**IMPERIAL METALS CORPORATION
MT. POLLEY PROJECT**

**RESPONSE TO REVIEW COMMENTS
ON TAILINGS EMBANKMENT DESIGN
(REF. NO. 1625/6)**

JANUARY 25, 1996

FIGURE 3

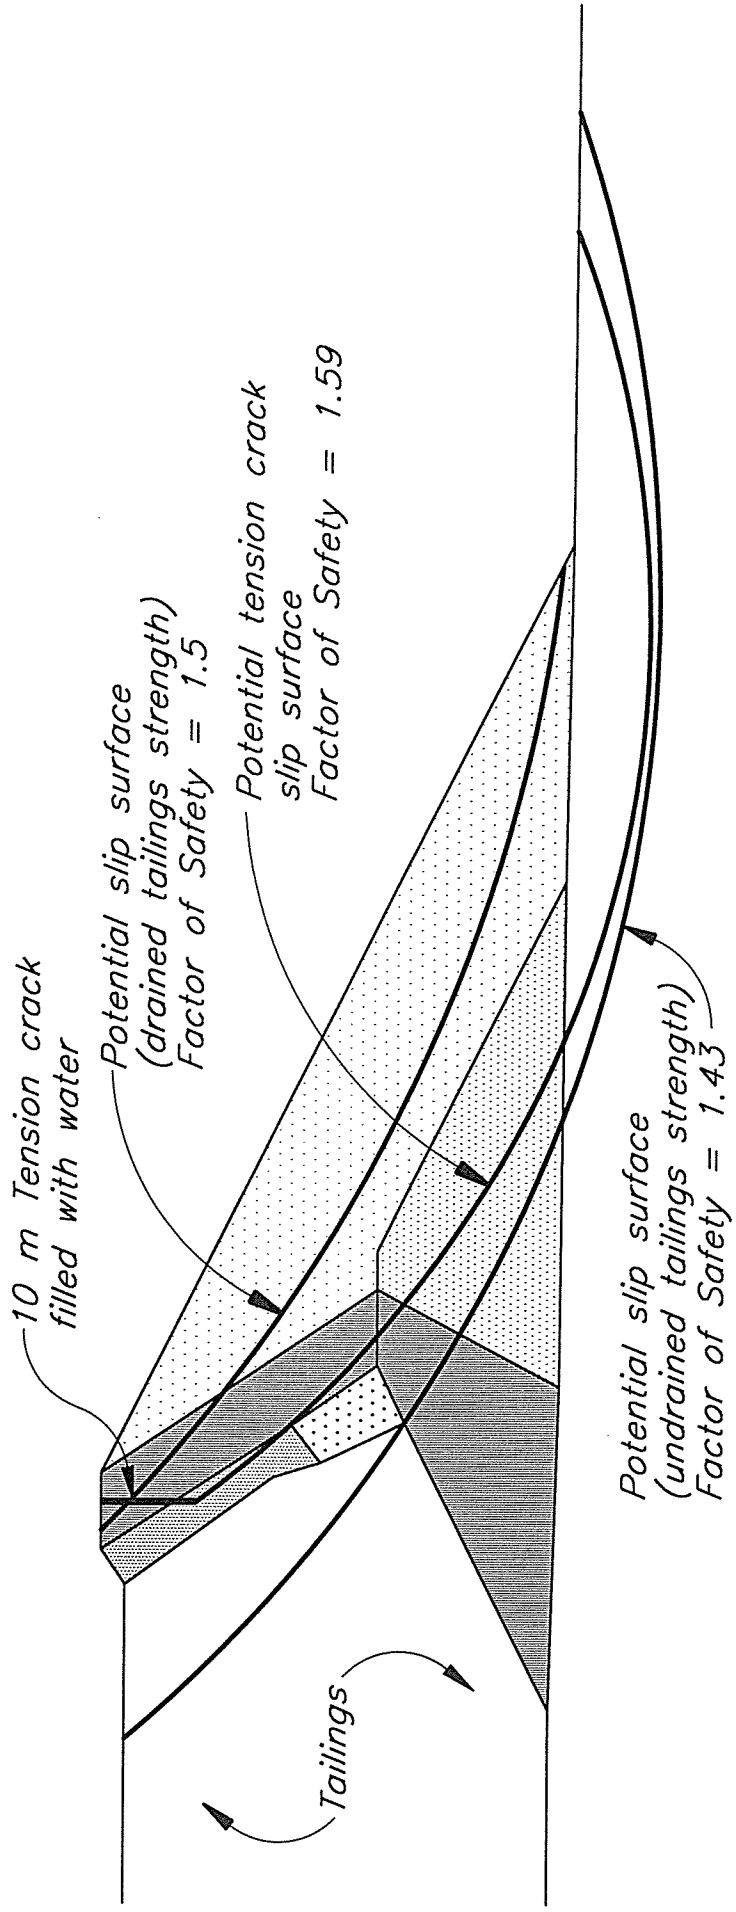
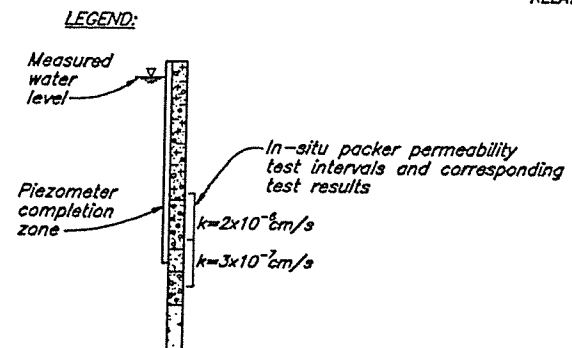
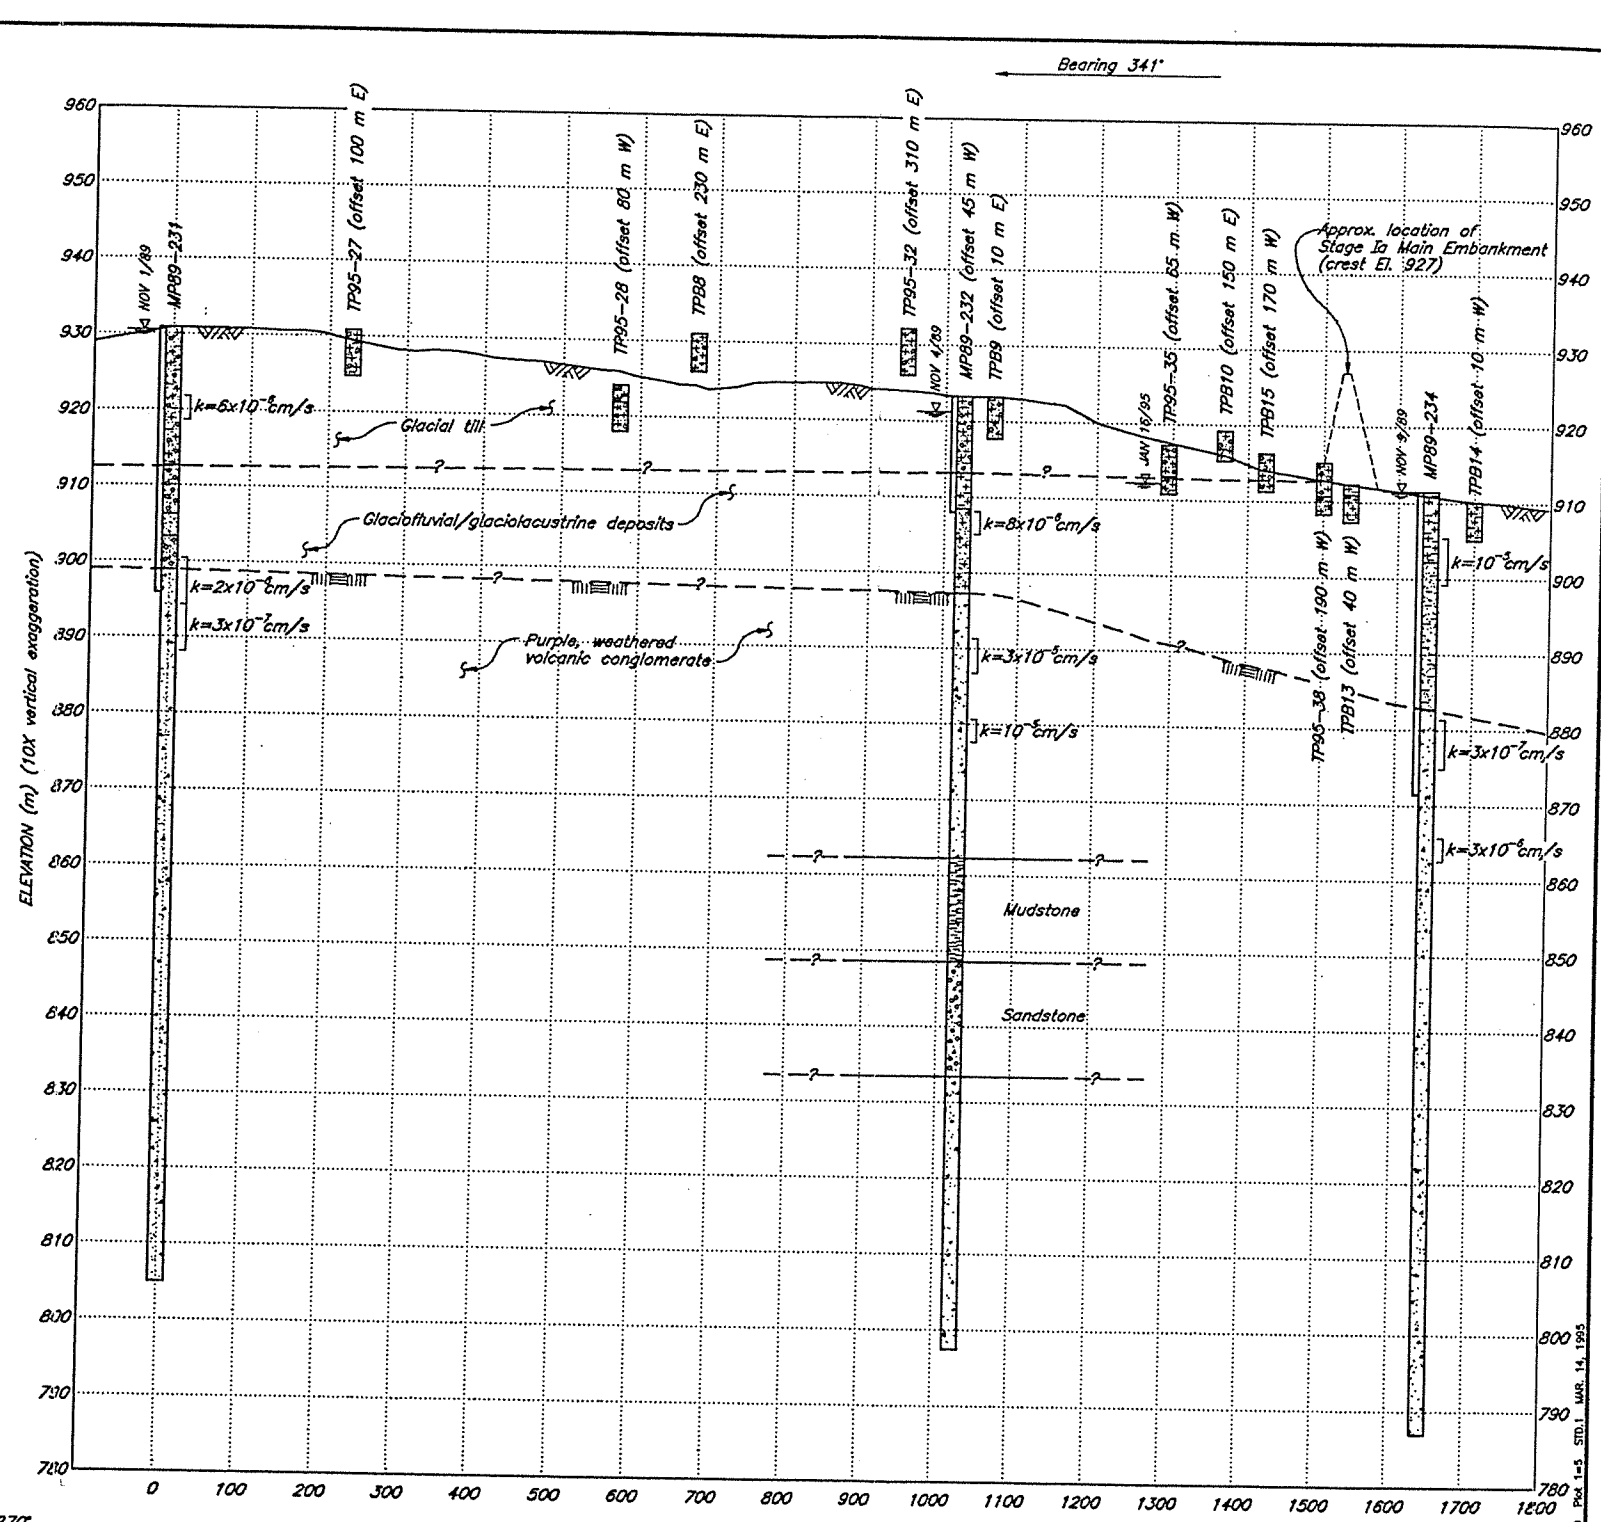
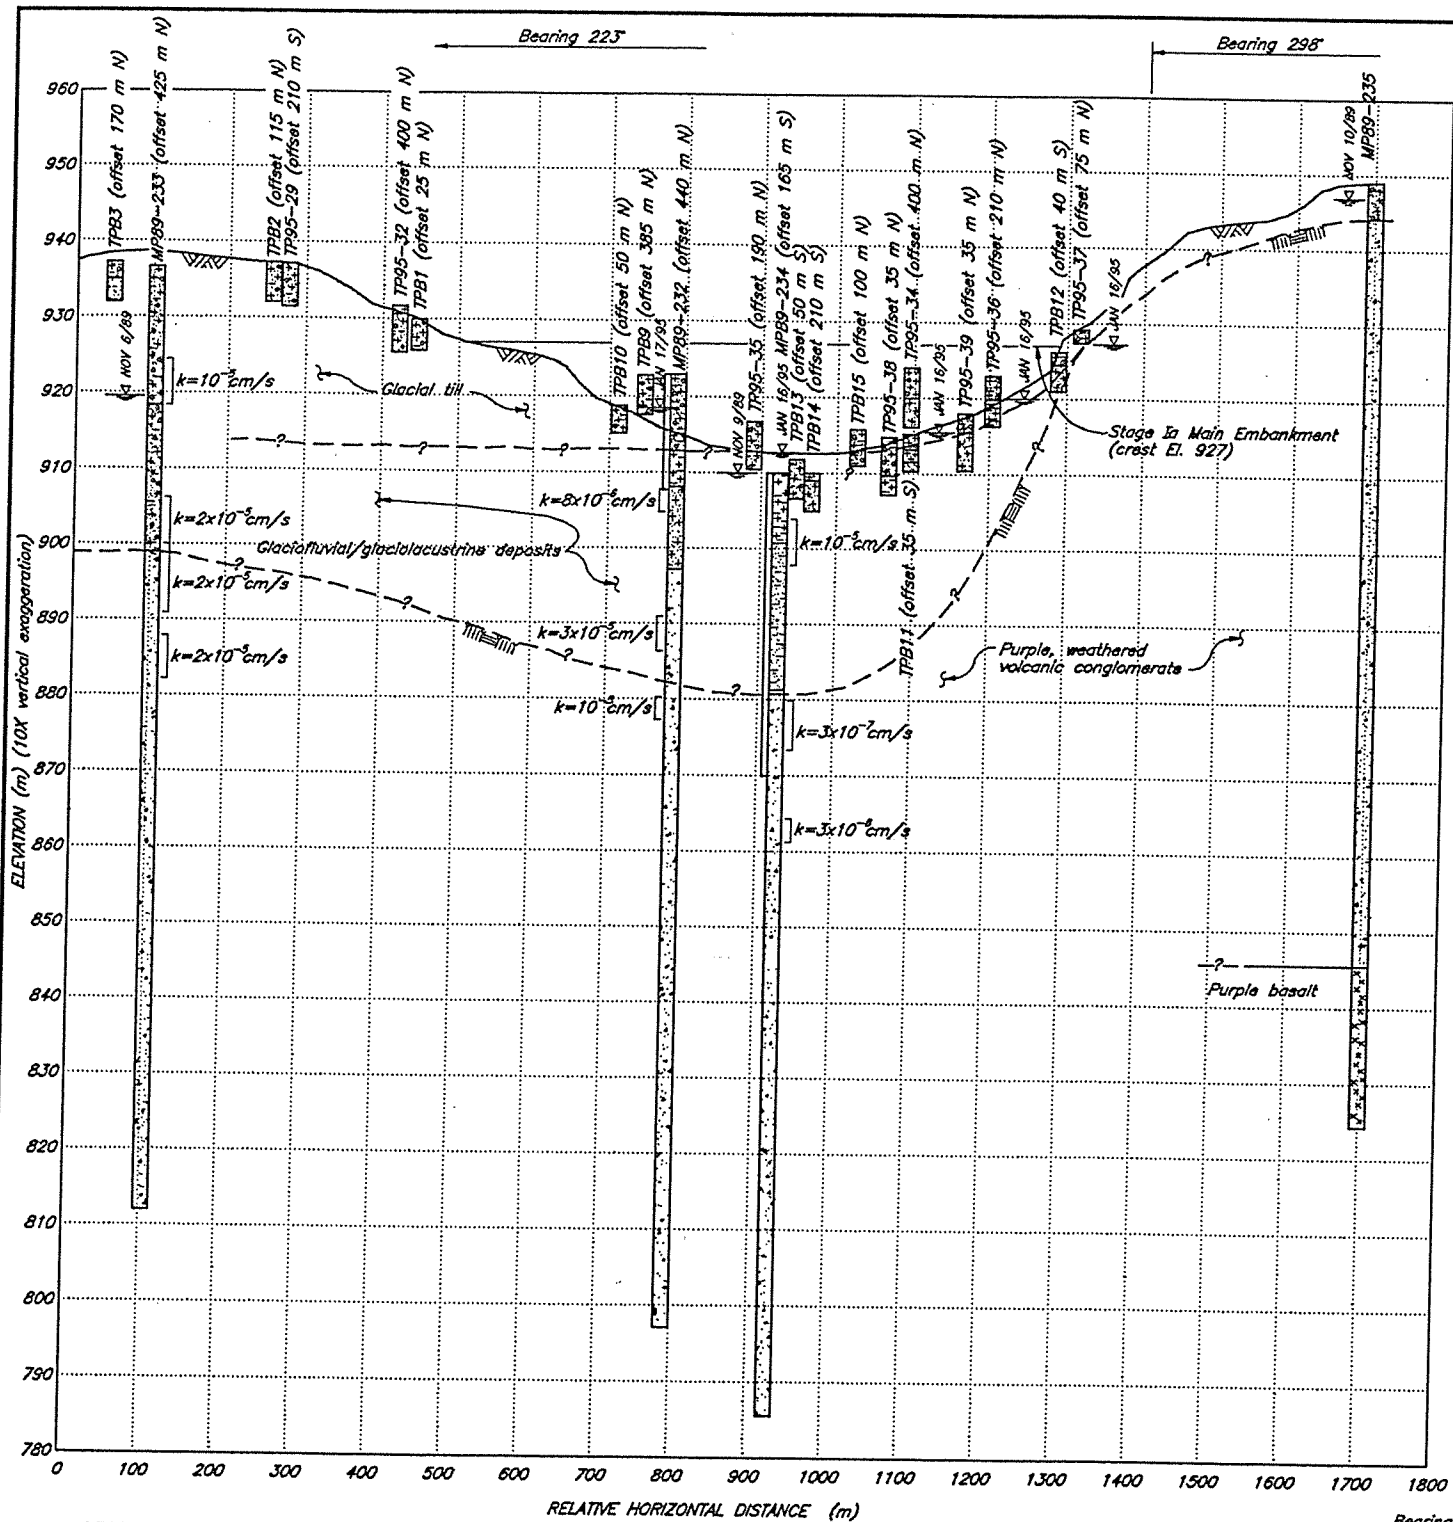
The design proposed entails some of the compacted main dam to be constructed over loose to medium dense tailings. With this design variability in consolidation characteristics would be expected. This could lead to tension cracks near the top of the main dam and generally parallel to C.L. Stability analysis should allow for 10 m deep tension cracks filled with water.

Based on our experience with similar construction methods and comparable tailings materials, it is highly unlikely that 10 m deep tension cracks can develop along the crest of the embankment. However, as suggested by Mr. Brawner, stability analyses have been conducted for a 10 m deep tension crack filled with water, as shown on Figure 3. The factor of safety for the water filled tension crack is higher than for the previously reported stability analyses. Therefore, the previously reported minimum factors of safety for the tailings embankment are unchanged even if a 10 m water filled tension crack occurs.

An upstream slip surface for a 10 m water filled tension crack was also evaluated. The results showed that this case is also not critical as the factor of safety is well in excess of 1.5.

**TAILINGS STORAGE FACILITY
GEOLOGICAL CROSS-SECTIONS**

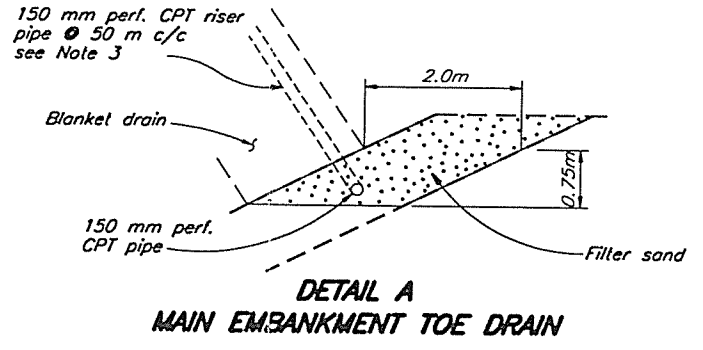
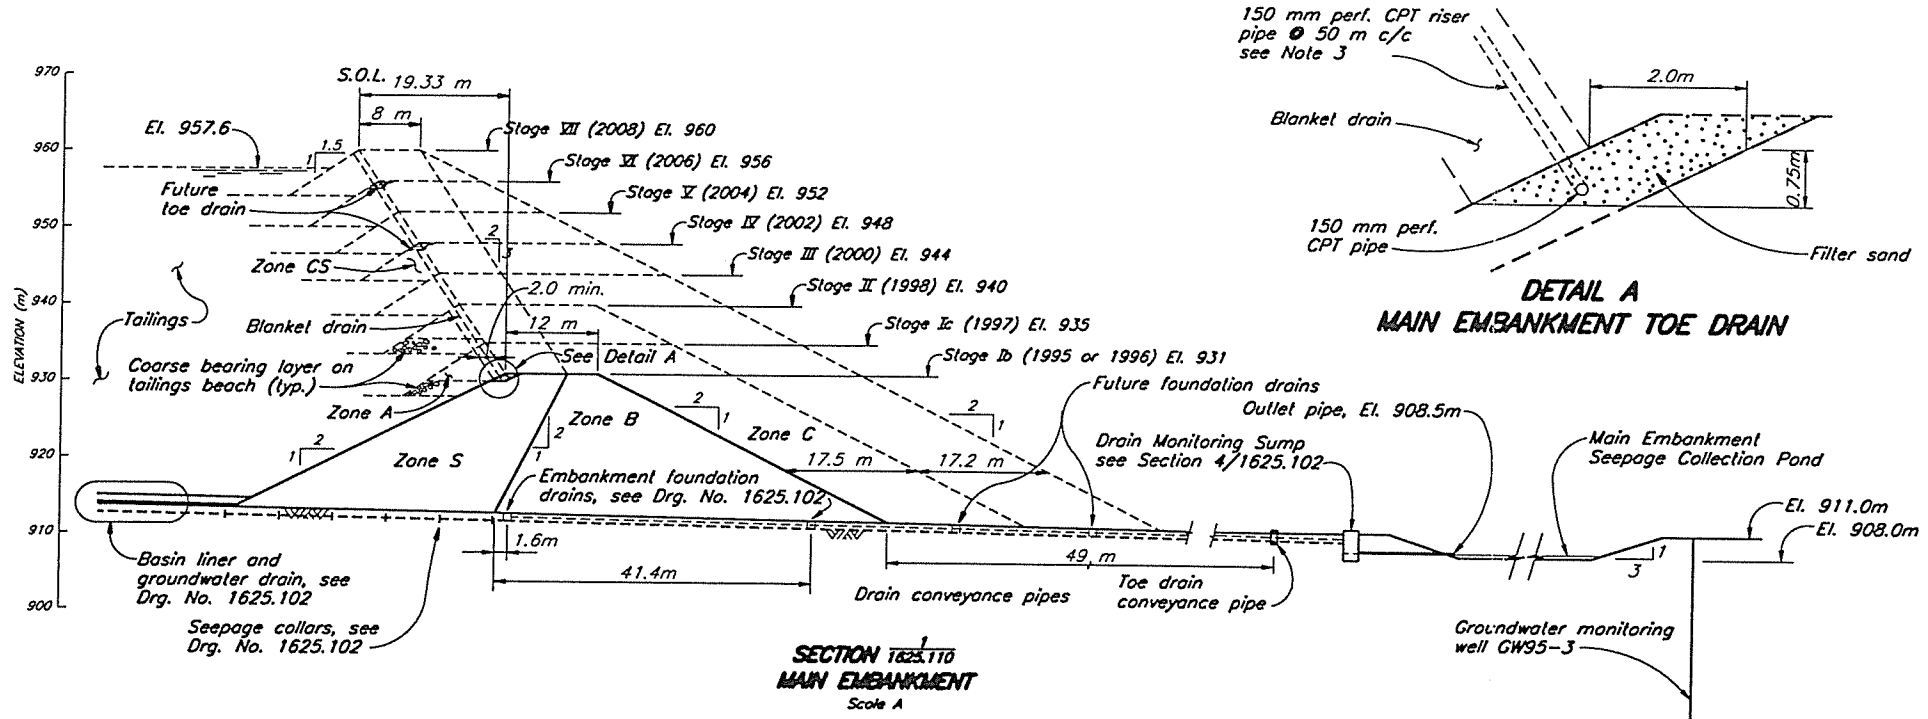
If the liner is placed it is suggested that a seepage cut-off be excavated and backfilled through the sediments near the upstream toe of the main embankment.

The nature and distribution of the geologic units, as described above and as shown on Drawing No. 1623.103, illustrate that it would be extremely difficult to construct a seepage cut-off at the upstream toe of the Main Embankment. In order for the cut-off wall to be effective, it must be extended to low permeability materials both vertically and laterally or else the seepage losses will merely be redirected to a different direction. Therefore, the seepage cut-off would have to be extended completely along the West Embankment. The seepage cut-off wall would be extremely difficult to construct and it is unlikely that it would provide any additional benefit and could actually result in a less efficient seepage control measures than the currently designed system.
